Staff Report

Infill Housing Design Review Committee

File Number: 3-L-22-IH

Location: 3425 Gap Rd. **Parcel ID** 81 I T 007
Zoning: RN-2 (Single-Family Residential Neighborhood)
District: Lonsdale Infill Housing Overlay District

1 Site Setbacks & Layout
 A100 1" = 20'-0"

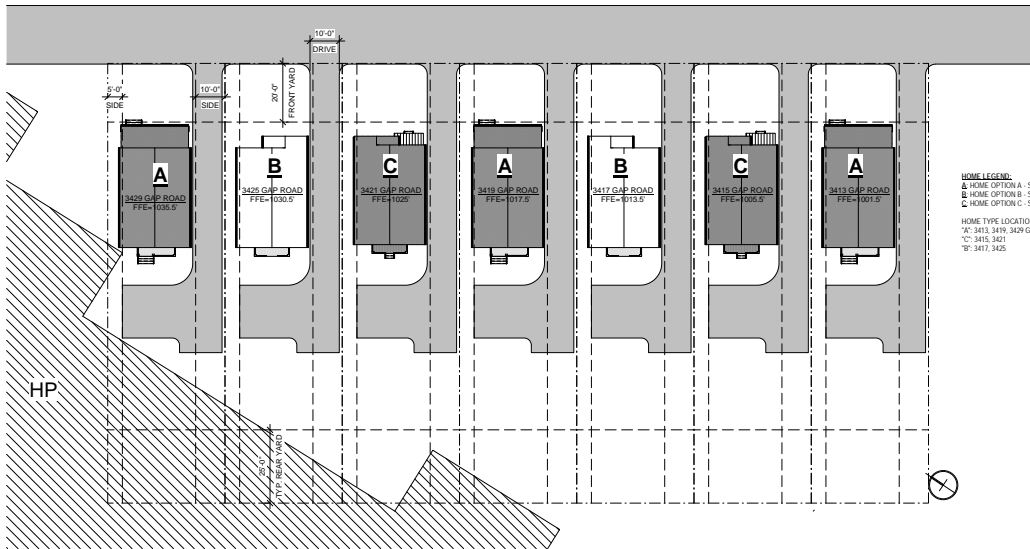
1. The proposed front setback is 24' from the front property line. There are only three other houses on the block. 3401 Gap Road is located 42' from the front property line, and the new construction houses at 3405 and 3409 Gap Road are also set 42' from the front property line. The subject property is one of seven new houses to be constructed on the block, so the front setbacks will effectively create a new street pattern. The submitted site plans do not specifically call out the front setback measurement. Overall, the proposed front setbacks should be confirmed to create consistent front yard spaces along the block.

The seven adjacent new houses will demonstrate consistent side yard setbacks while accommodating the necessary side driveways. The applicant should confirm the left side exterior walls of all 7 houses will stay within the 5' side setback required allow windows on side elevation walls.

3. There is no operable alley on the block. The proposed parking meets Infill Housing design guidelines by limiting access to one lane between the street and the façade, and the design benefits from the parking pads being placed behind the house. As proposed, the site plans meet City Engineering standards, but any modifications in permitting should meet Engineering standards and Infill Housing design guidelines.

9. Final site plans should incorporate one native or naturalized shade tree in the front and rear yards.

- 1) Front setback should be confirmed to create consistent front yard space along the block, with approval of final site plans by staff;
- 2) Left side setback to be a minimum of 5', so the left side elevations can retain windows;
- 3) Final site plan to meet City Engineering standards and Infill Housing design guidelines;
- 4) Revise design of front porch to meet design guidelines, with approval by staff;
- 5) Revise façade and side elevation windows to better meet design guidelines, with approval by staff;
- 6) Final site plan to show one tree in front and one tree in rear yard.

Drawn: MSG
 HOME OPTION B - EXTERIOR ELEVATIONS

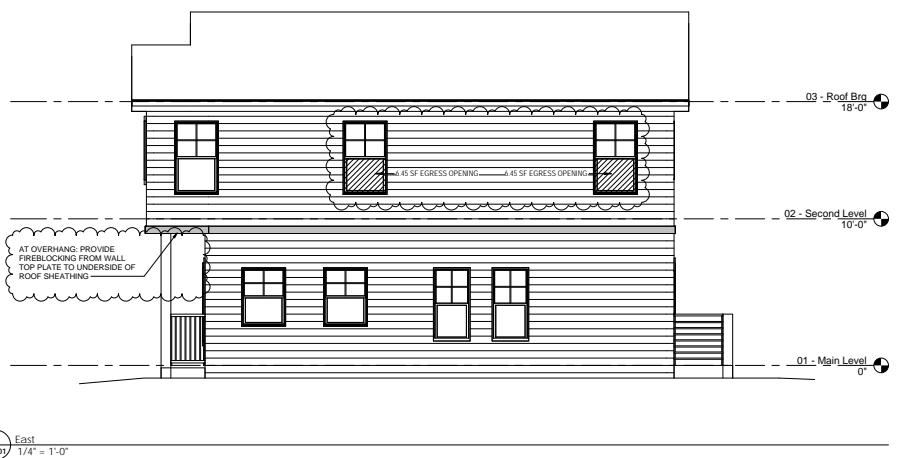
4. The proposed front elevation is similar in scale to other houses along the street, especially the adjacent infill construction. The 22' wide, three-bay façade is comparable to historic houses' façade widths. The lower front-gable roof massing and porch roof contribute additional roofline complexity. The applicant should provide foundation heights for the proposed houses.

5. Design "B" proposes a 3' wide entry stoop underneath the cantilevered massing instead of a porch. The new house should incorporate a porch to meet design guidelines.

6. Guidelines note that "window and door styles should be similar to original or historic houses" in the surrounding context. 1/1 windows instead of the proposed 4/1 would be more appropriate for the surrounding context. The façade does not show windows in "similar proportion and position" as original houses in the neighborhood, including the three-part picture window and the single fixed window, which are disproportionate in size. The side elevations show multiple sizes of windows with somewhat irregular placement. The left side elevation would benefit from an additional bay of windows closer to the façade, as the large swath of wall with no transparency will be significantly visible from the street.

7. At 6/12, the roof has a similar pitch to original houses in the neighborhood.
